yellowstone county multi-use building
YELLOWSTONE EXHIBITION GROUNDS
BILLINGS, MONTANA

S-19

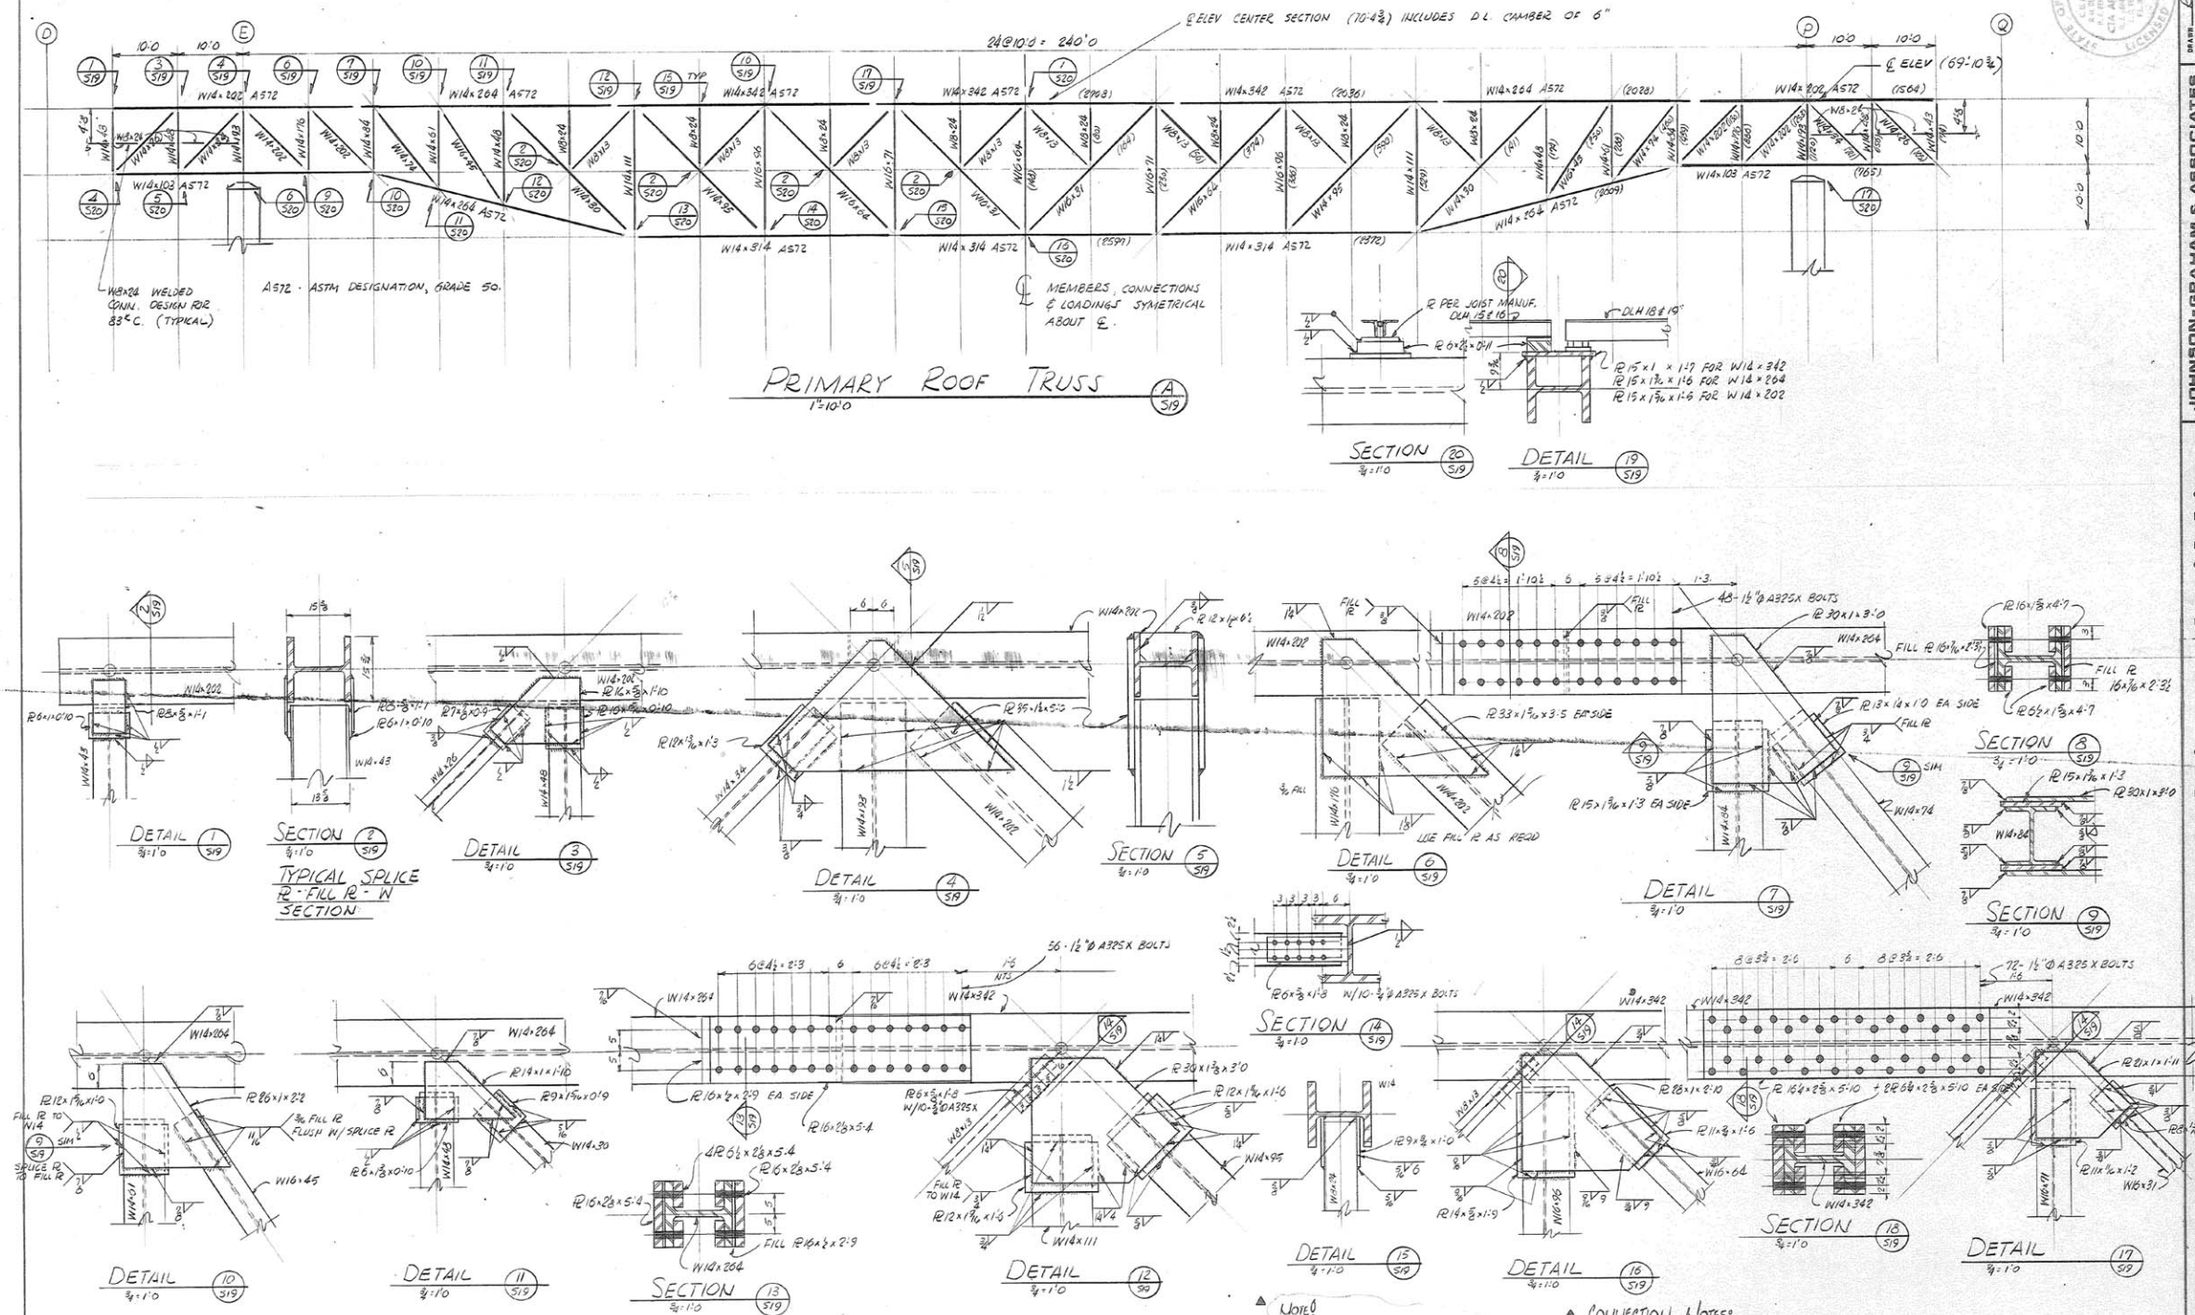
▲ NOTE: CONNECTIONS TO A36 MEMBERS MUST BE ONLY A36 PL.

▲ REVISED 7 MAR '74 W.K.
